Service Bulletin

Product Family: 915105

Subject: Potential Incorrect Ground Wire Location

Model	Serial Number Range	Description
915105	000101 – 000174	Zoom 2150

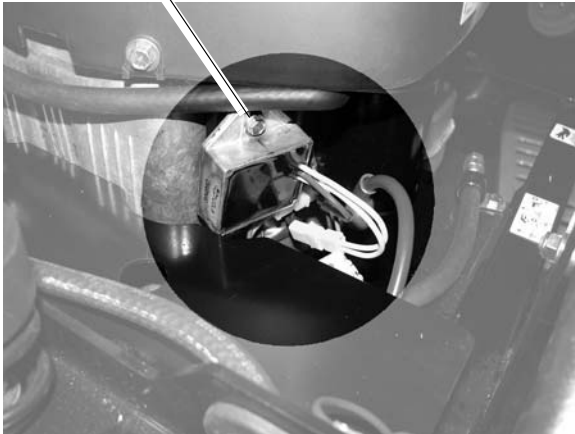
Ariens has learned that Zoom model 915105 units in the serial number range listed above may have the battery and solenoid ground wires connected to the screw used to mount the voltage regulator to the engine. This location does not allow for a good battery ground, which can cause the solenoid ground wire to overheat and lead to premature failure.

Inspect the voltage regulator mounting screw. If ground wires are connected here, move them to the seat spring plate.

This unit requires no action.

Before putting any of these units into service, inspect the voltage regulator on the front left side of the engine. If the battery and solenoid ground wires are connected to the mounting hardware, reconnect them to the seat spring bracket as shown in the figure on page 2. If there are no ground wires connected to the voltage regulator mounting hardware, the unit is properly grounded and needs no further action.

If the ground wires were connected to the voltage regulator, connect the solenoid and battery ground wires here instead.

NOTE: Make sure the ground wires get good metal to metal contact with the seat spring plate. You may need to scrape away some paint to make a good ground contact.
